PROPOSED ORDINANCES AMENDING CHAPTER IX OF THE LOS ANGELES MUNICIPAL CODE IN THE ADOPTION OF THE 2010 CALIFORNIA BUILDING CODES, INCLUDING THE ELECTRICAL, MECHANICAL, PLUMBING AND THE NEW 2010 CALIFORNIA RESIDENTIAL CODE.

The enclosed proposed "Building Ordinances" package contains the same information previously submitted on August 31, 2010. However, we have revised the proposed ordinances by cleaning up the grammatical errors and by removing the "Reasons" for the proposed amendments. Therefore, please replace the old packaged with this most current "Revised" package.

The Building Code Ordinance, amends Article 1, Chapter IX, of the Los Angeles Municipal Code by adopting the 2010 California Building Code (C.B.C.) and the 2010 California Residential Code (C.R.C) by reference with local amendments. The California Building Code adopts the 2009 International Residential Code by reference and the 2010 California Residential Code adopts the 2009 International Residential Code. Many of the local amendments to the code were based on the recommendations of the Los Angeles Regional Code Program. The Regional Code Program has the support of 89 jurisdictions to provide consistency in code i

STEPPED FOUNDATIONS
FIGURE 4805.4 1809.3

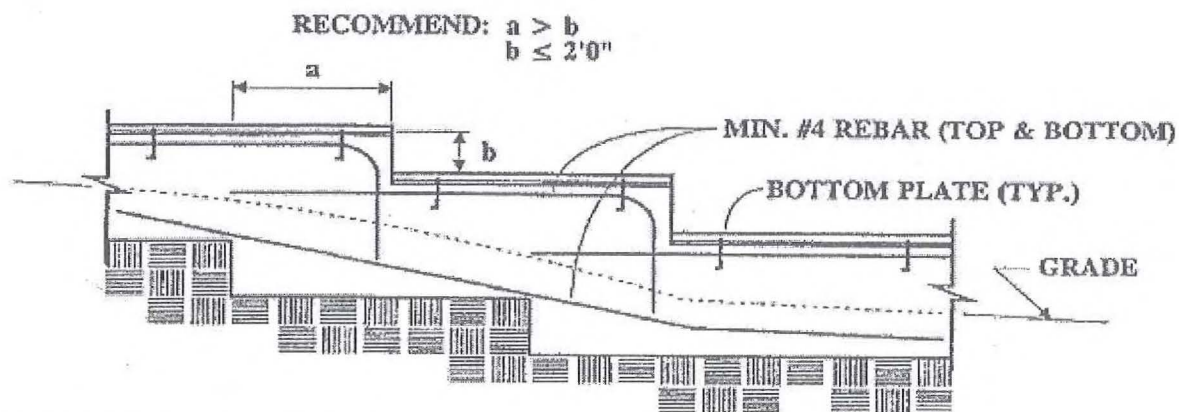
91.1809.3 Stepped Footing. The top surface of footings shall be level. The bottom surface of footings shall be permitted to have a slope not exceeding one unit vertical in 10 units horizontal (10-percent slope). Footings shall be stepped where it is necessary to change the elevation of the top surface of the footing or where the surface of the ground slopes more than one unit vertical in 10 units horizontal (10-percent slope). This stepping requirement shall also apply to the top surface of grade beams supporting walls. Footings shall be reinforced with four ½ inch diameter (12.7 mm) deformed reinforcing bars. Two bars shall be placed at the top and bottom of the footings as shown in Figure 1809.3 of this Code.

Figure 91.R503.2.4

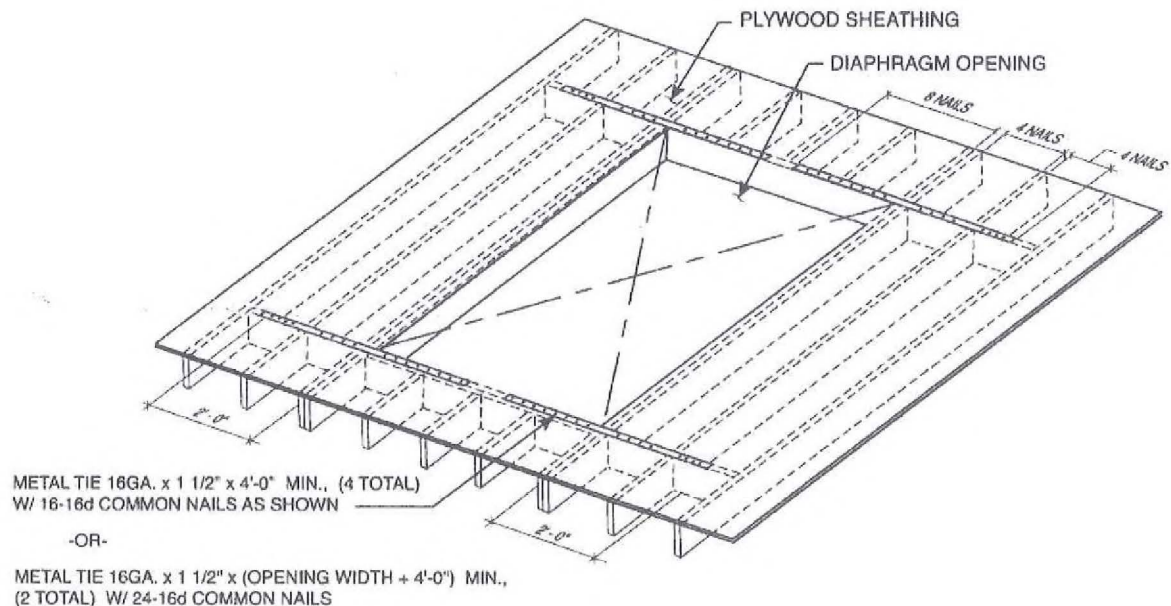
91.R503.2.4 Openings in horizontal diaphragms. Openings in horizontal diaphragms with a dimension perpendicular to the joist that is greater than 4 feet (1.2 m) shall be constructed in accordance with Figure 91.R503.2.4.

FIGURE ~~R602.10.3.3~~ 91.R602.10.3.3
METHOD PFH: PORTAL FRAME WITH HOLD-DOWNS

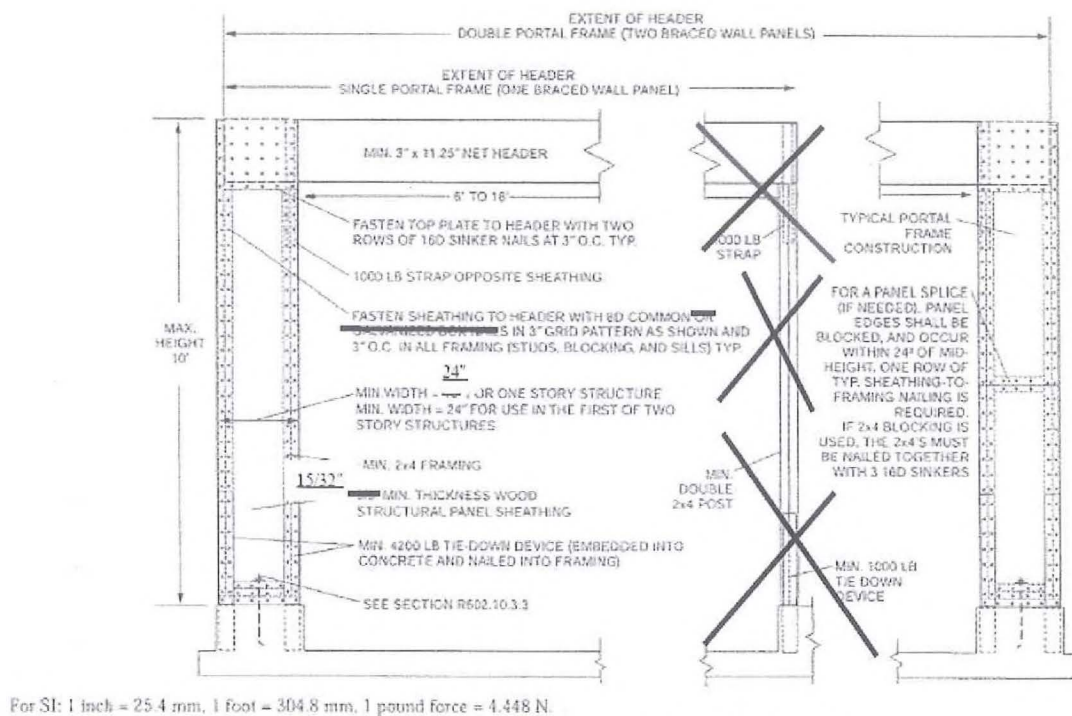
91.R602.10.3.3 Method PFH: Portal frame with hold-downs. Method PFH *braced wall panels* constructed in accordance with one of the following provisions are also permitted to replace each 4 feet (1219 mm) of *braced wall panel* as required by Section 91.R602.10.3 for use adjacent to a window or door opening with a full-length header:

1. Each panel shall be fabricated in accordance with Figure 91.R602.10.3.3. The wood structural panel sheathing shall extend up over the solid sawn or glued-laminated header and shall be nailed in accordance with Figure 91.R602.10.3.3. A spacer, if used with a built-up header, shall be placed on the side of the built-up beam opposite the wood structural panel sheathing. The header shall extend between the inside faces of the first full-length outer studs of each panel. One anchor bolt not less than 5/8-inch-diameter (16 mm) and installed in accordance with Section R403.1.6 shall be provided in the center of each sill plate. The hold-down devices shall be an embedded-strap type, installed in accordance with the manufacturer's recommendations. The panels shall be supported directly on a foundation which is continuous across the entire length of the braced wall line. The foundation shall be reinforced as shown on Figure 91.R602.10.3.2. This reinforcement shall be lapped not less
